METROPOLITAN GOVERNMENT OF NASHVILLE AND DAVIDSON COUNTY

STAFF RECOMMENDATION
119 3rd Avenue South
September 20, 2017

Application: New construction, Rehabilitation, Signage-violations
District: Broadway Historic Preservation Zoning Overlay
Council District: 19
Map and Parcel Number: 09306403000
Applicant: Bill Miller
Project Lead: Paul Hoffman, paul.hoffman@nashville.gov

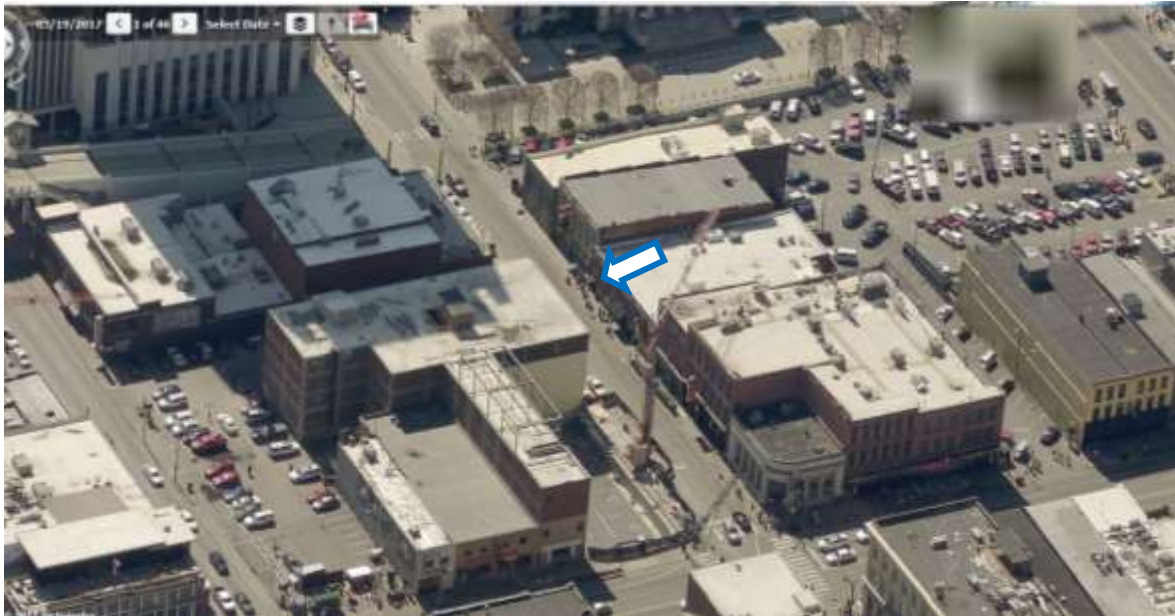
<p>Description of Project: A roll-up door was installed without review or permit. Signage has been installed without review or permit for a building that has already exceeded its allotment.</p> <p>Recommendation Summary:</p> <p>Staff recommends removal of the three vinyl signs (rear wall sign, 3rd Ave wall sign and 3rd Ave shingle sign) and the left-corner painted sign, installed without a permit, finding that they do not meet the design guidelines for allotment or materials.</p> <p>Staff recommends disapproval of the roll-up door finding that it does not meet Section II.B. of the design guidelines for rehabilitation of doors and entryways.</p> <p>Staff further recommends that the violations be removed no later than October 20, 2017, providing 30 days for correction.</p>	<p>Attachments A: Photographs</p>
---	---

Staff recommends removal of the three vinyl signs (rear wall sign, 3rd Ave wall sign and 3rd Ave shingle sign) and the left-corner painted sign, installed without a permit, finding that they do not meet the design guidelines for allotment or materials.

Staff recommends disapproval of the roll-up door finding that it does not meet section II.B of the design guidelines for rehabilitation of doors and entryways.

Staff further recommends that the violations be removed no later than October 20, 2017, providing 30 days for correction.
